INSPECTION REPORT
Sedimentation Structure
J28-D
Kayenta Mine
Navajo County, Arizona
for
PEABODY COAL COMPANY

Dames & Moore
10139-011-22

Plate 1

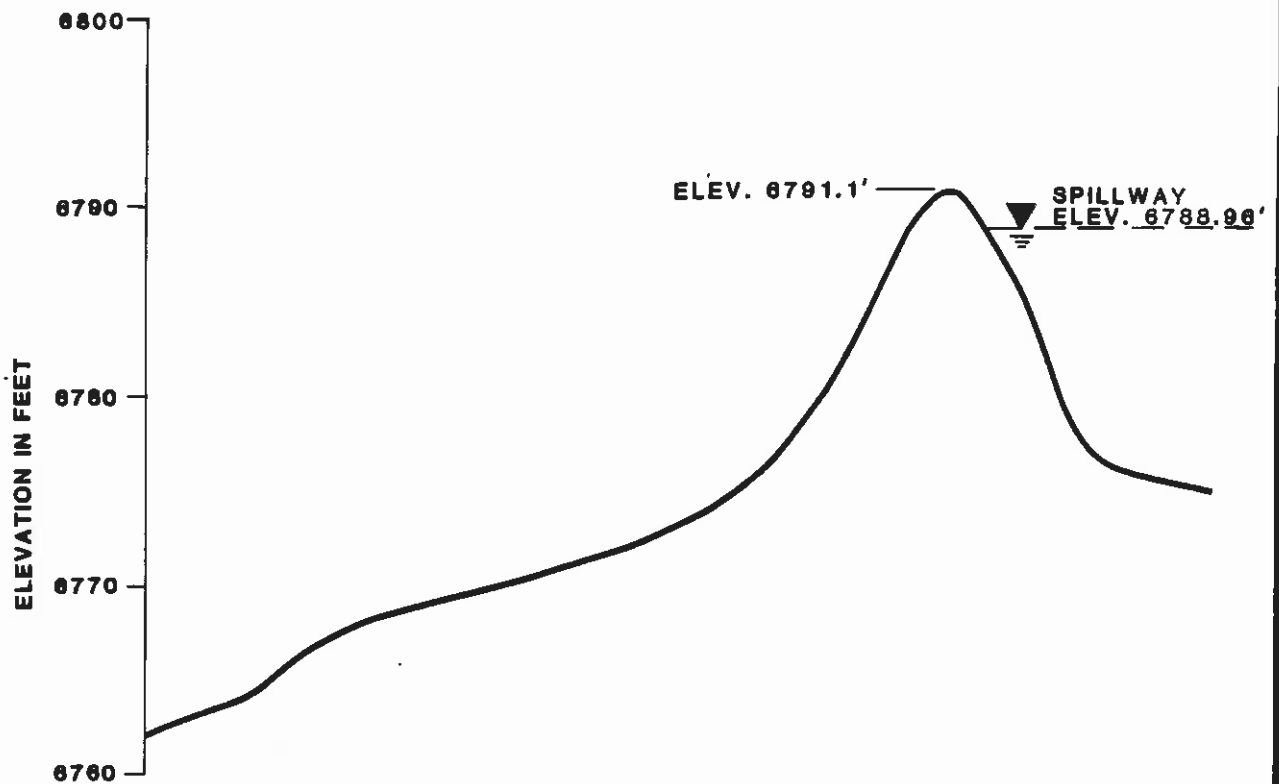
The storage capacity and spillway capacity of Structure J28-D are adequate; however, the spillway does not have an adequate outflow channel or adequate erosion protection. A trapezoidal outflow channel should be constructed along the alignment B-B' shown in Plate 1. The channel profile is shown in Plate 4 and the required dimensions are shown in Plate 5. Both the spillway and outflow channel should be protected against erosion using geotextile and gravel as shown in Plate 5.

EXISTING
MAXIMUM CROSS-SECTION
A-A'
J28-D

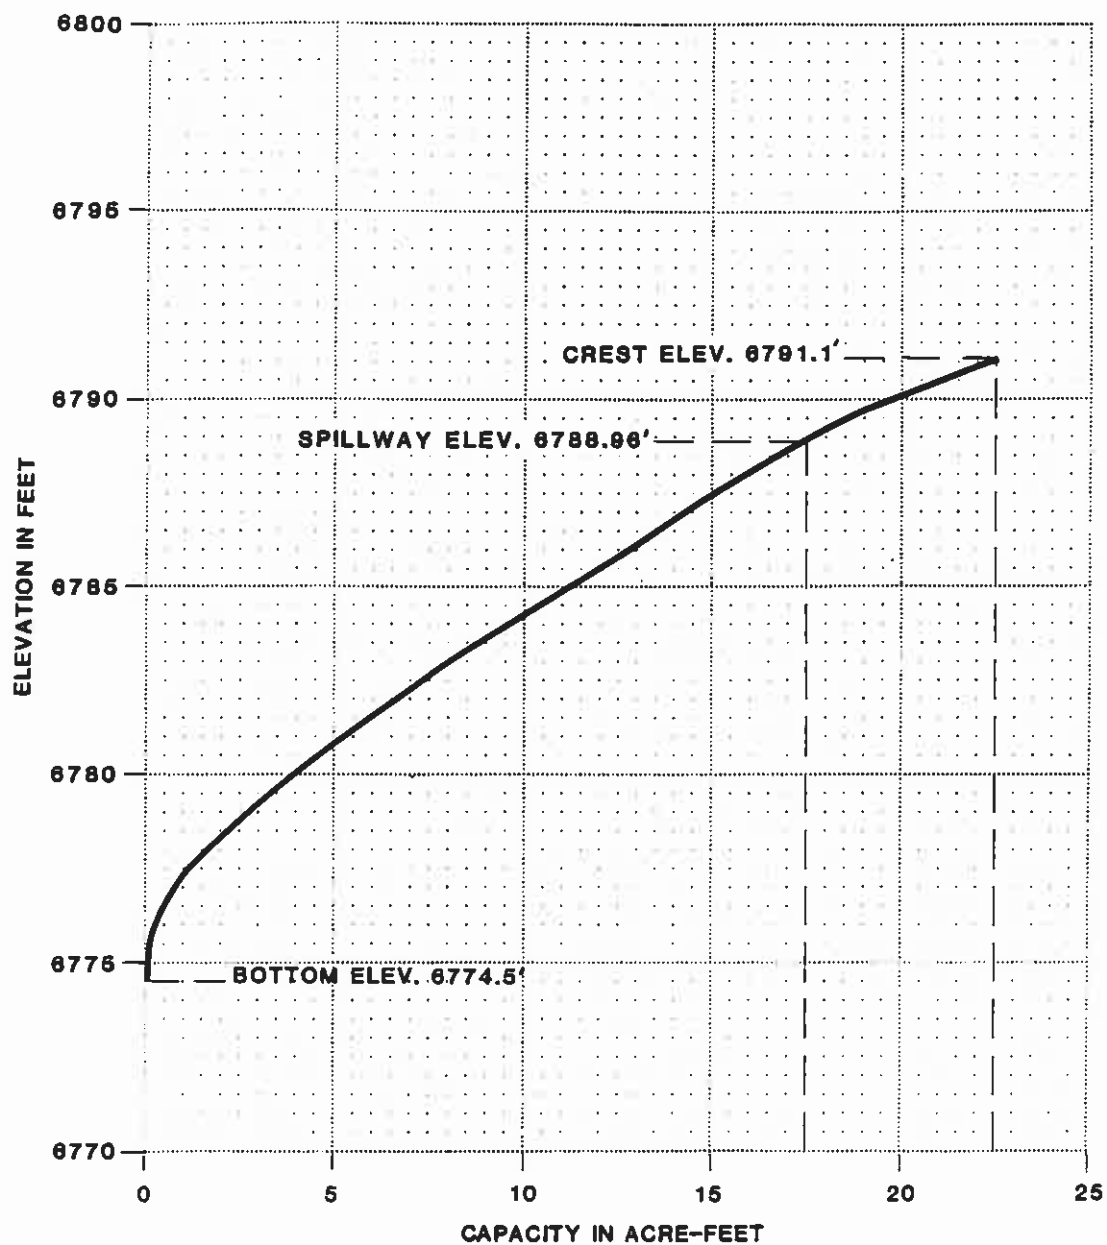
The J28-D embankment is lower in height; however, the downstream slope is steeper than the category standard; therefore, the embankment has factors of safety less than the design minimum.

The inspection of Structure J28-D indicated that the only geotechnical problem is rill and gulley erosion on the upstream slope. Correction of erosion is considered a periodic maintenance task and does not require remedial action. The downstream slope should be flattened to 2.5 horizontal to 1 vertical to meet stability requirements.
